SERVICE DIRECTIVE BULLETIN

SERVICE DIRECTIVE BULLETIN NO. 0116
Revision 3

DATE: April 11, 2023

1. SUBJECT: Cyclic and Collective Control Tube Assembly Inspections
2. MODEL: F-28F, F-28F-R, 280FX and any additional models that have been modified by adding rubber boots
3. EFFECTIVITY: F-28F Series: Serial Numbers 747 through 832*
280FX Series: Serial Numbers 2013 through 2147*
*All Models: Any earlier Serial Number modified with the Control Tube Cover Installation
4. REFERENCE: Enstrom F-28A/F-28C Series Maintenance Manual, Latest Revision
Enstrom 280/280C Series Maintenance Manual, Latest Revision
Enstrom F-28F/280FX Series Maintenance Manual, Latest Revision

Figure 1. Inspection areas; (a) collective control tube assembly and cyclic control tube assembly ((b) as viewed from the cabin through the backwall and (c) as viewed through the upper left side engine cowling).

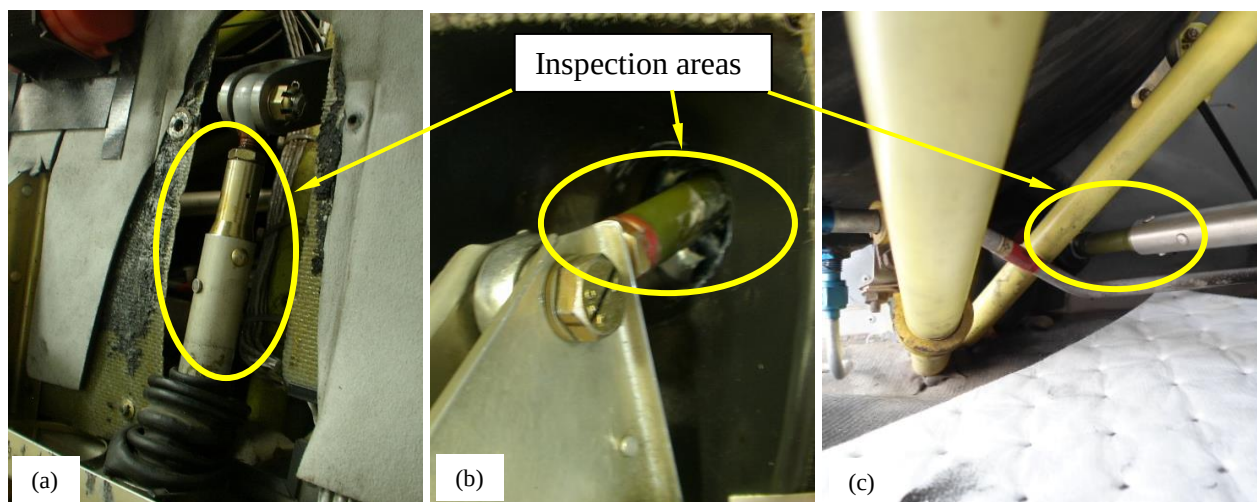
7.7. Locate the cyclic (lateral and longitudinal) and collective control tube assemblies (Figure 1). Remove the tie wrap and inspect the surface near and under the boot for corrosion (Figure 2). Use a flashlight or bright light source as necessary for the inspection.

7.8. If the condition of the control tube assembly is satisfactory, no additional inspection is required. Re-install the boot over the tube assembly and tie wrap.

7.9. If corrosion is detected and damage is less than 0.010" (0.25 mm deep), perform the following:

7.10. If corrosion is detected and damage exceeds 0.010" (0.25 mm deep), perform the following:

Figure 3: Cyclic and Collective Control Tube Cover Installation

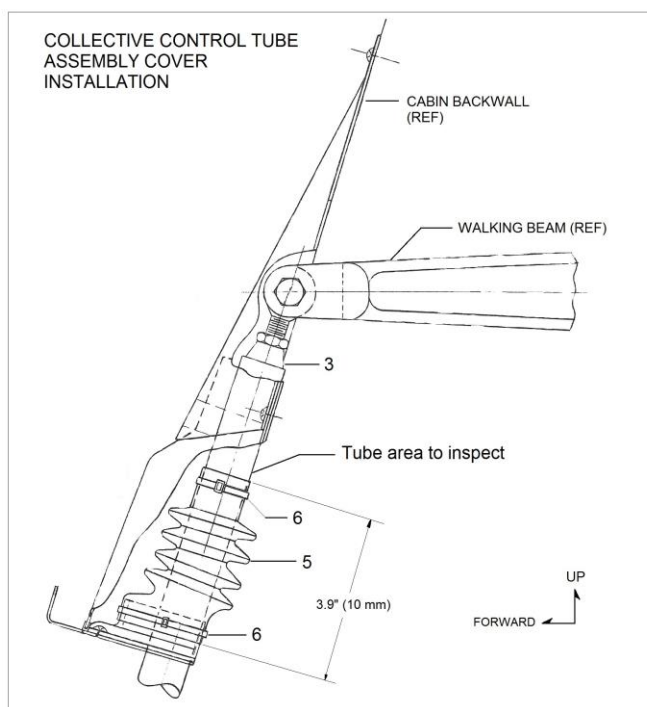
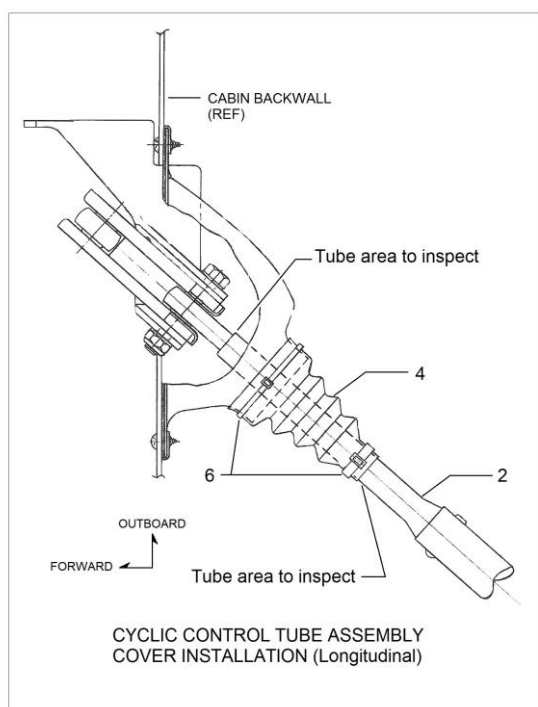
7.10.5. Install boot to indicated length in Figure 3.

7.10.5.1. Position collective in full up position when cable tie is added at this dimension.

9.1. Replacement parts: see Figure 3 below.
